Final Revised Supplemental Environmental Impact Report

East Dublin Properties Stage 1 Development Plan and Annexation

Comments and Responses

SCH No. 2001052114

East Dublin Properties
FIGURE 2-G
Stage 1 Development Plan

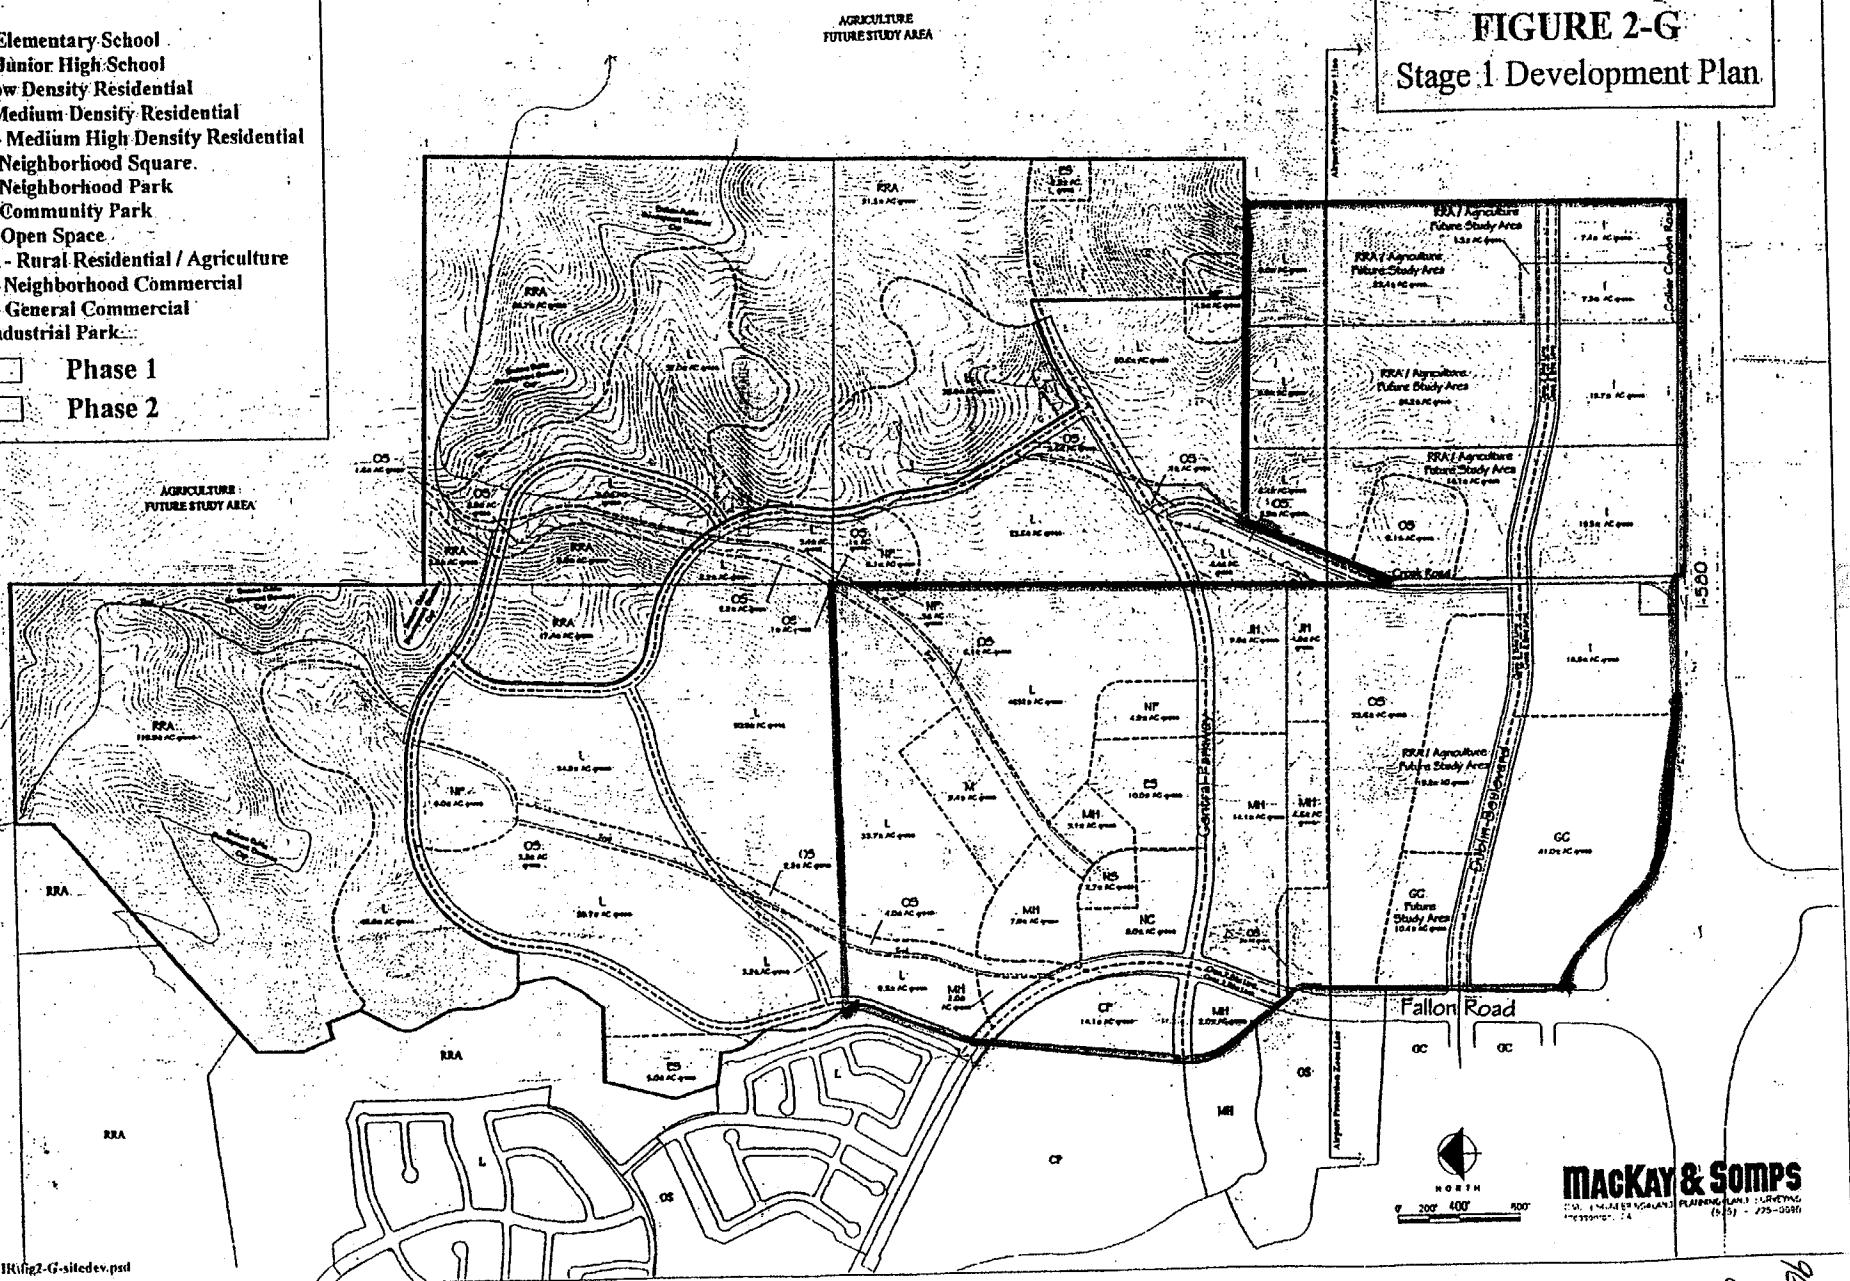
Figure 2-G also indicates that a trail would be built within the 100-foot-wide corridor. This is also inconsistent with mitigation measure BIO-SM-13 because a trail so close to riparian habitat would be a significant adverse impact on the CRLF (and other species), exceeding the "minor impact on the habitat" as allowed in mitigation measure BIO-SM-13.

Response 10.15.j.5: The comment states that Figure 2-G depicts a trail to be built within the 100-foot wide riparian corridor, which is inconsistent with SM-BIO-13.

East Dublin Properties
FIGURE 10.1

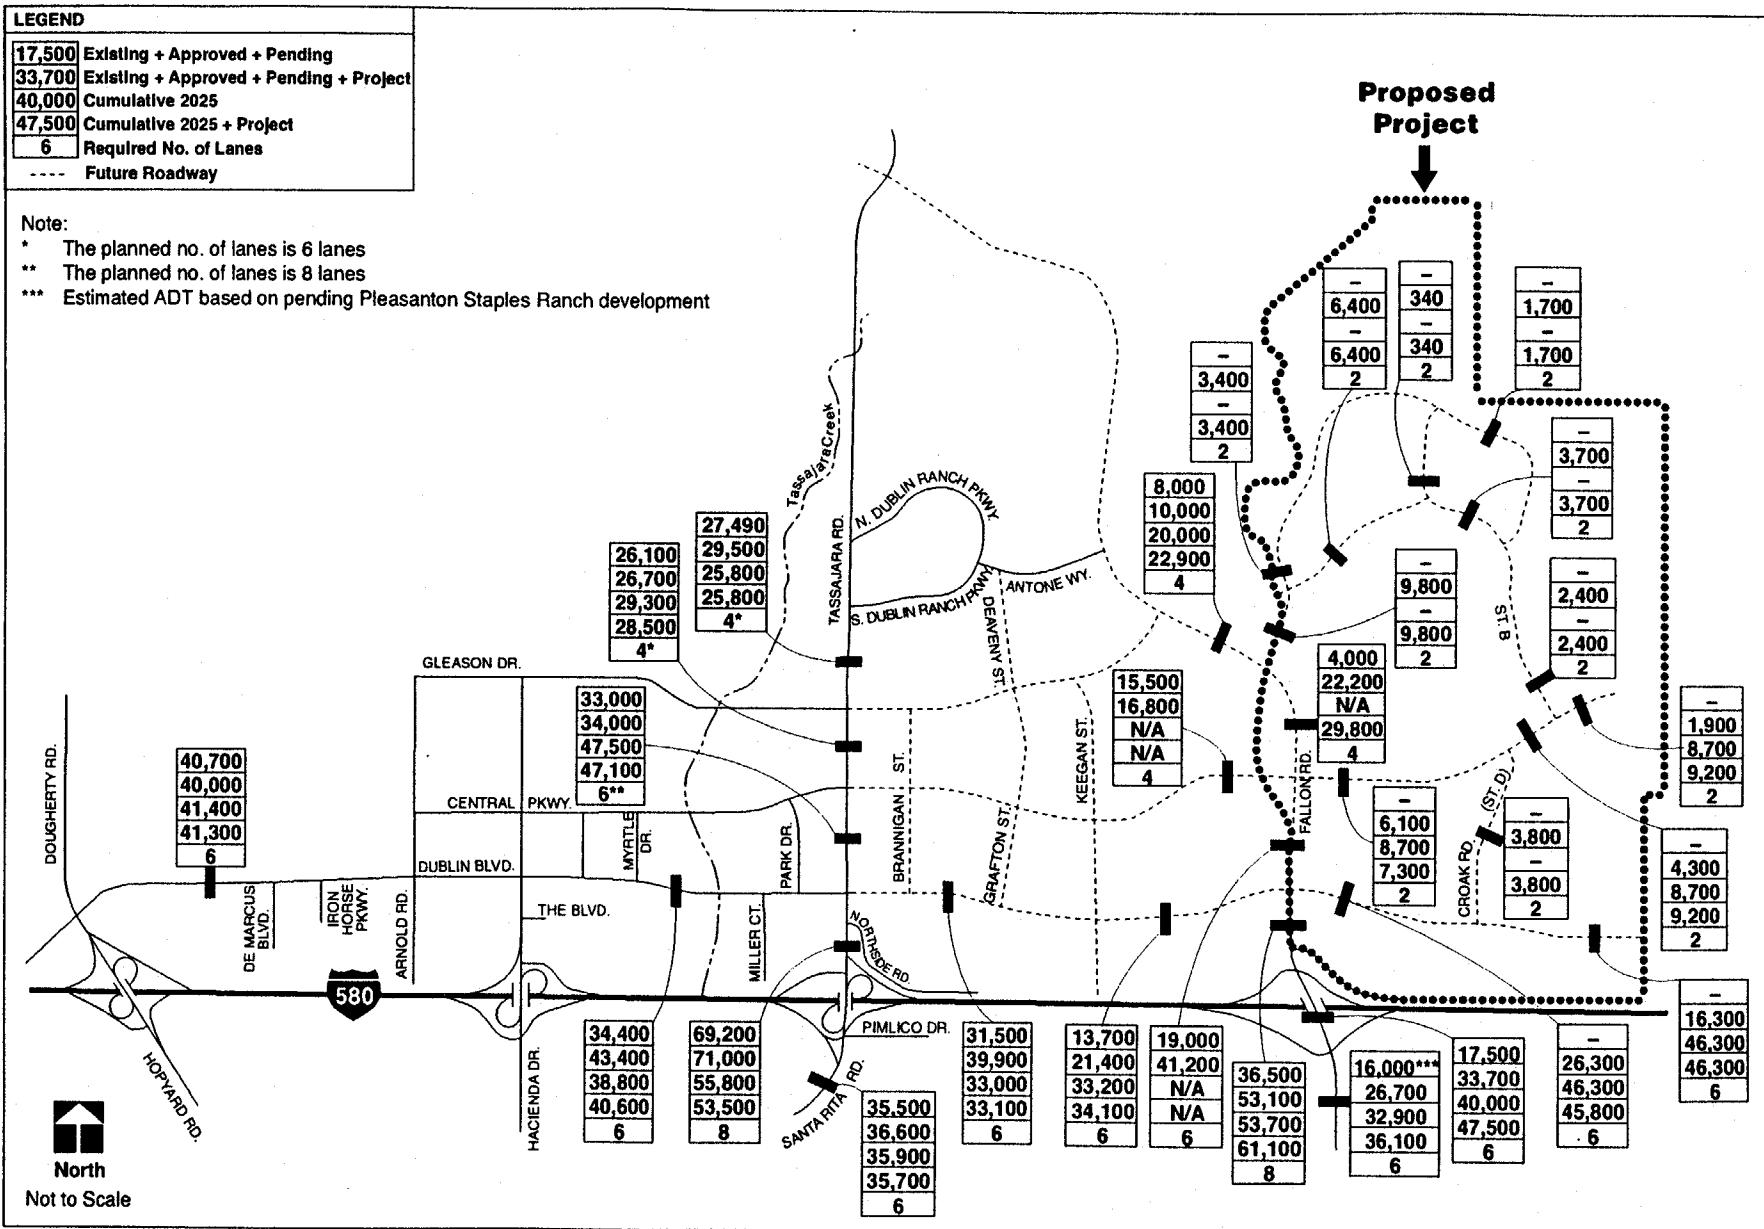
Response 10.14.a: Central Parkway. The comment states that the discussion in the Revised DSEIR with respect to the location of Central Parkway in the Extended Planning Area located east of the Project Area is confusing and internally inconsistent. The comment also concludes that only two conclusions can be drawn from the information -that Central Parkway east of Fallon Road is missing from the Project Description or that Central Parkway east of Fallon Road as it loops southeast to Dublin Boulevard must occur somewhere other than within the project site -- and concludes that in either case the Revised DSEIR must be revised and recirculated again.

The comment states that certain figures (2-C, 2-G, 2-H, 2-L, 3.3-C, 3.4-B and 3.6-A through 3.6-F) do not show that Central Parkway loops southeast to connect to Dublin Boulevard, as is shown on the General Plan (Figure 5-1b). These Figures do show a road (sometimes labeled as Croak Road and sometimes labeled as Road "D") connecting Central Parkway and Dublin Boulevard in the general location as the loop road shown on General Plan Figure 5-1b.

As stated in the footnote on page 3.6-22 of the Revised SDEIR, the location of the collector streets within the Project Area and the possibility of using Croak Road (or Street D) as the connector for Central Parkway to Dublin Boulevard will be determined by tentative maps and Site Development Review stages of the Project, when these are submitted for individual properties within the Project Area. Since the alignment of the streets within the Project Area cannot be determined at this time, the traffic analysis did not assume that Croak Road would be used as the connector for Central Parkway to Dublin Boulevard. For this reason, the daily traffic volume projected for Croak Road in Year 2025 with

Project was relatively low (e.g., 3,800 vehicles per day versus 9,200 vehicles per day on Central Parkway).

If a determination is made at a future tentative map and Site Development Review stage to realign Croak Road to serve as the connector for Central Parkway to Dublin Boulevard, one possible realignment is shown for illustrative purposes only in Figure 10.1. The estimated daily volumes shown in Figure 3.6-F of the Revised DSEIR for Croak Road and for Central Parkway (east of Fallon Road) would be reassigned to yield the volumes shown in Figure 10.1. Based on this reassignment of traffic, Central Parkway would carry an estimated 10,500 vehicles per day between Fallon Road and Street B, and 13,000 vehicles per day between Street B and Dublin Boulevard under 2025 plus Project conditions. These estimated daily volumes would require two lanes on Central Parkway (one lane in each direction) between Fallon Road and Dublin Boulevard, similar to the two-lane requirement specified for both Central Parkway (east of Fallon Road) and Croak Road in Figure 3.6-F of the Revised SDEIR. (To avoid confusion with the street names shown in Figure 3.6-F of the Revised SDEIR, this figure is revised as shown in Figure 10.2 to show the updated street names in Eastern Dublin in the vicinity of the Project Area.) Additionally, Supplemental Mitigation Measure SM-TRAFFIC-4 on page 3.6-16 of the Revised DSEIR to install a traffic signal at the Dublin Boulevard/Street D intersection would still be applicable, and the Central Parkway connector to Dublin Boulevard would function as Street D.

223 of 291
East Dublin Properties
FIGURE 3.3-B
Sensitive Species in the Eastern Dublin Area

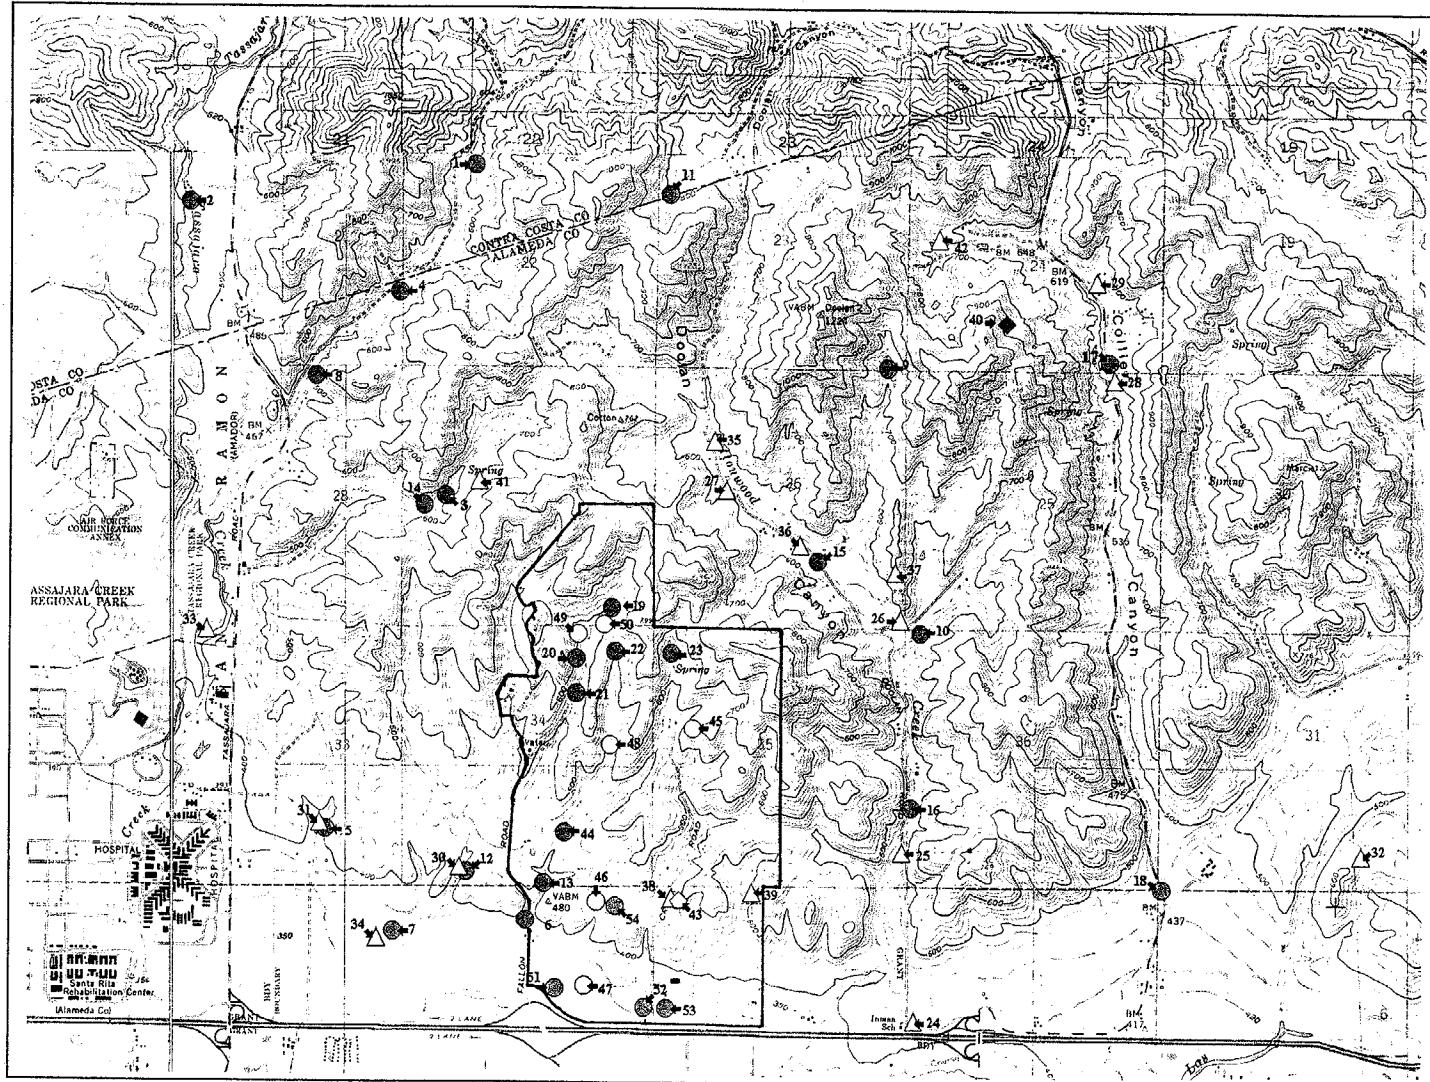
Area provide suitable RLF breeding habitat, and thus all streams in the Project Area must have a buffer zone of 600 to 1,000 feet pursuant to SM-BIO-13, which is not consistent with the riparian open space corridors depicted in Figures 2-F and 2-G.

Revised Figure 3.3-B has been updated to include all known observations of red-legged frogs from the Project Area. The quoted passage from the comment is in error, as it confuses "critical habitat" with recommendations made in the USFWS Draft Recovery Plan for the California red-legged frog. As correctly noted on pages 3.3-5 and 3.3-18 of the Revised DSEIR, the Project Area is within the East Bay-Diablo Range Critical Habitat Unit (Unit 15), and also is within the Mount Diablo Core Area (Core Area 23) of the South and East San Francisco Bay Recovery Unit (#4) proposed in the Draft Recovery Plan. These are separate designations. With respect to fill of waters of the U.S., the Project does not involve any fill, as the Project does not involve or approve any specific development. The Project is limited to annexation, rezoning, and approval of a general Stage 1 development plan for the Project Area. Before any development or any fill of waters of the U.S. can occur, owners of individual properties within the Project Area will thereafter have to develop detailed Stage 2 development proposals for their property (which proposals will be subject to City discretionary review and additional CEQA environmental review). The specifics of those detailed development proposals will determine whether any fill of waters of the U.S. will occur. Since Supplemental Mitigation Measure SM-BIO-5 requires avoidance of all such waters to the extent feasible, it is possible that no fill of waters of the U.S. will occur. Should fill of such waters be necessary, that fill must be permitted through the Army Corps of Engineers. Given the critical habitat designation referred to above, in such circumstance the Corps would be required to comply with Section 7 of the ESA, and engage in a formal consultation with USFWS.
